APPLICATION FOR SUBMITTAL OF POST-APPROVAL DOCUMENT

South El Monte High School Modernization

CCD-21

Project Reference: South El Monte High School Modernization Date: 11/21/2023

M3.L1
02/21

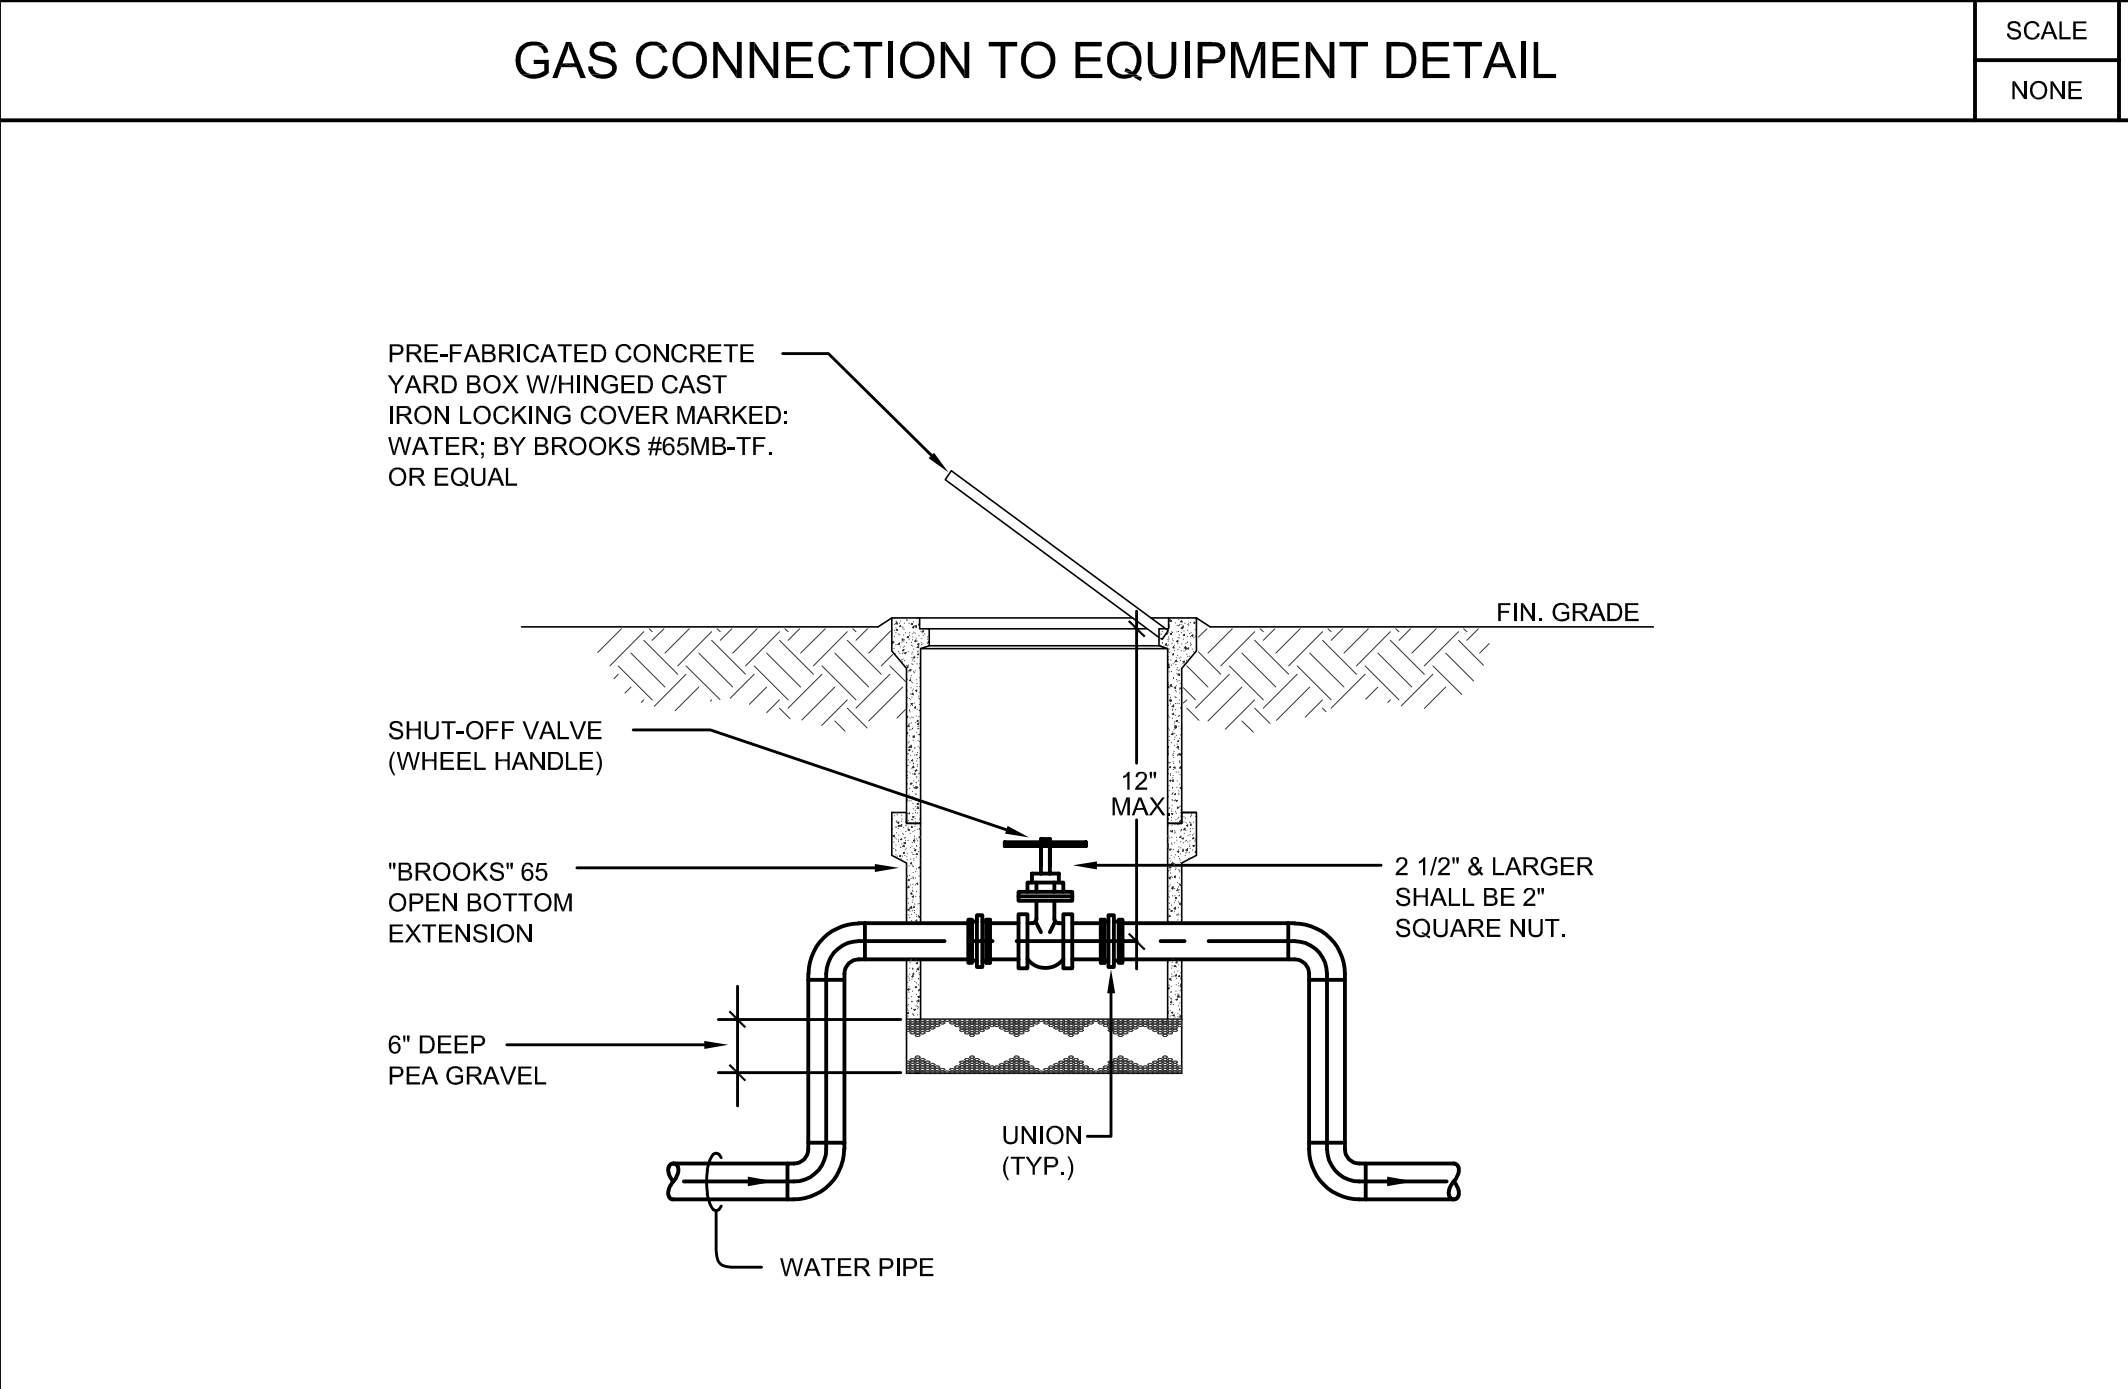
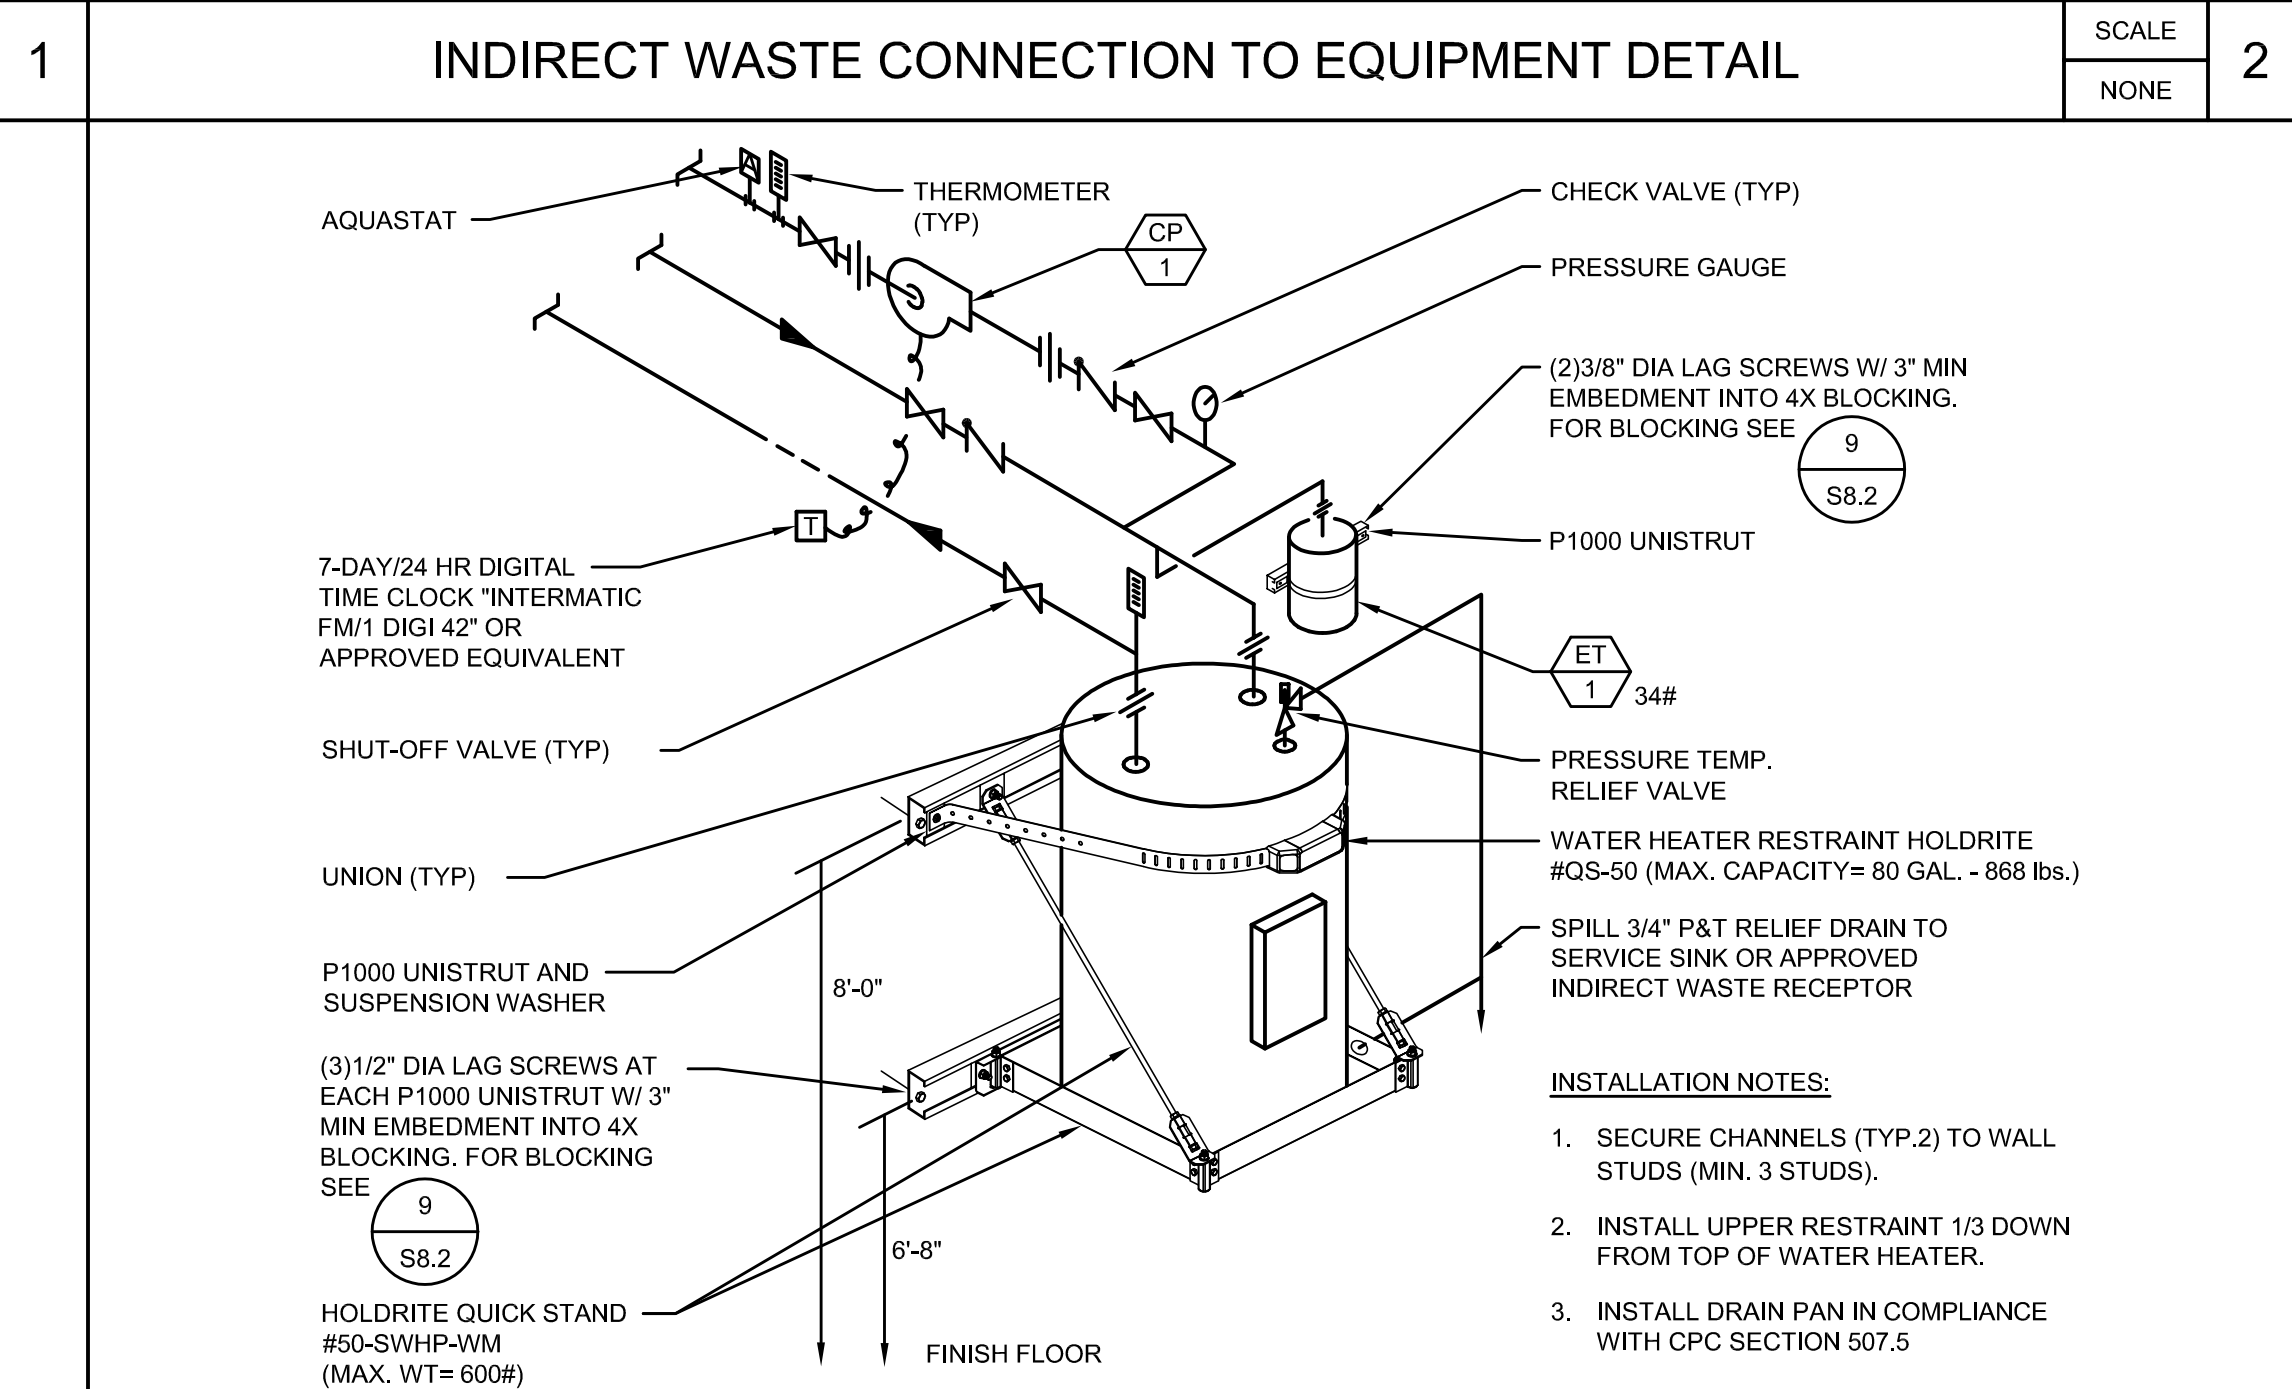
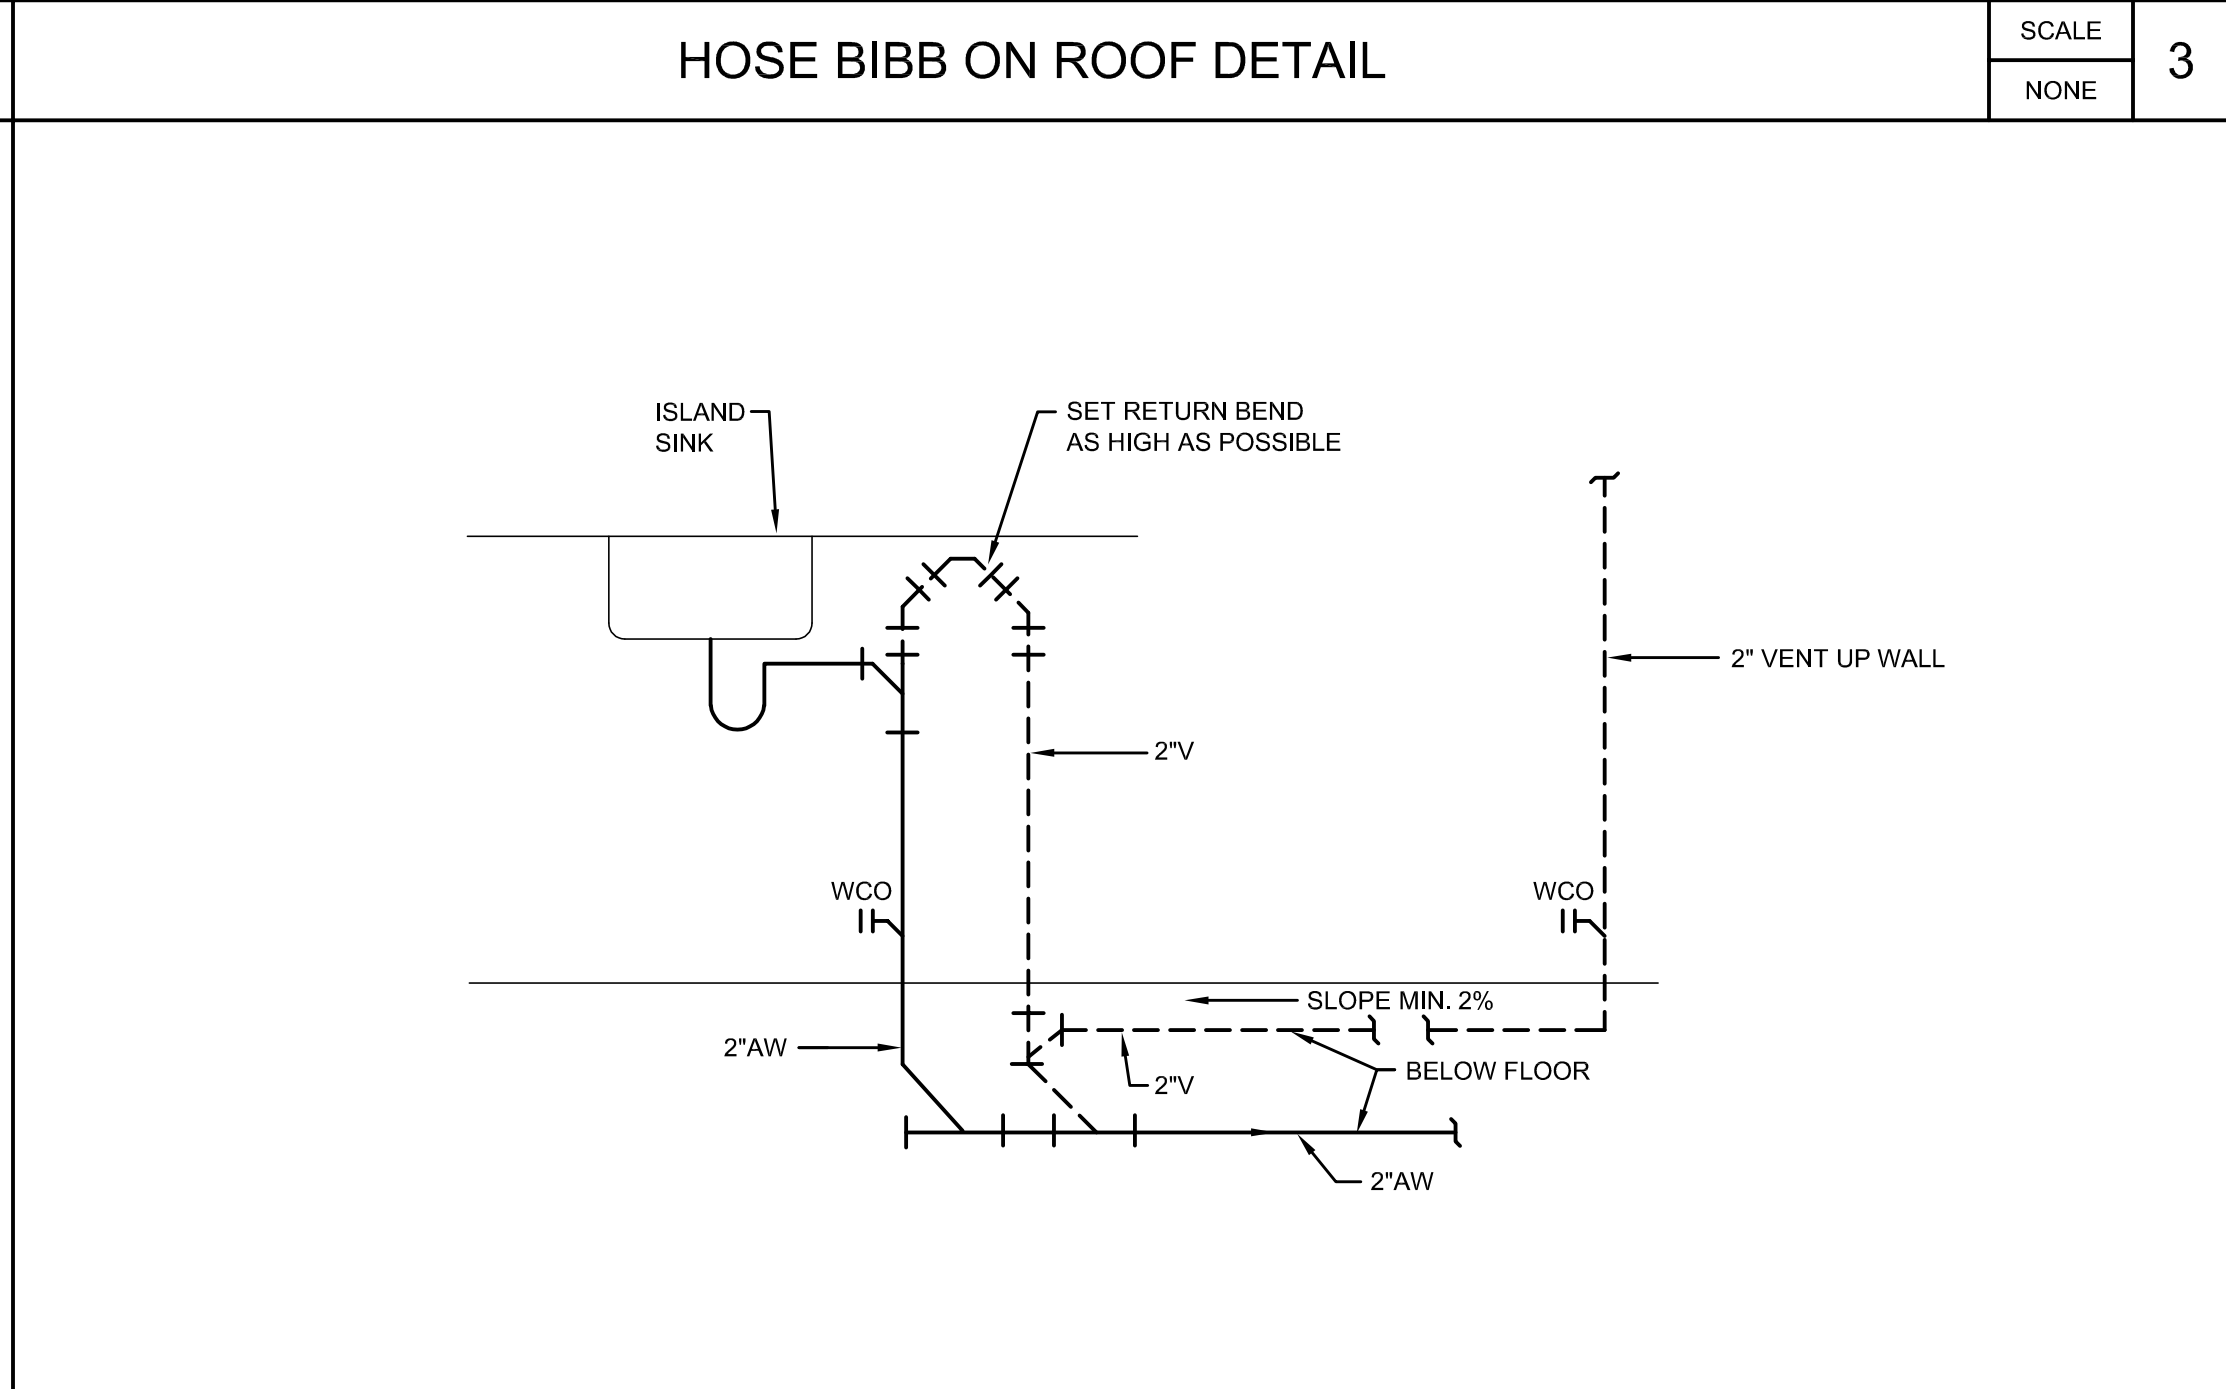
- 21.9. SHEET M3.L1 – MECHANICAL REMODEL ROOF PLAN – BLDG L**
21.9.1. New sheet provided to identify new RTU replacement units on the roof above the existing food service area. Units will replace existing units as noted.
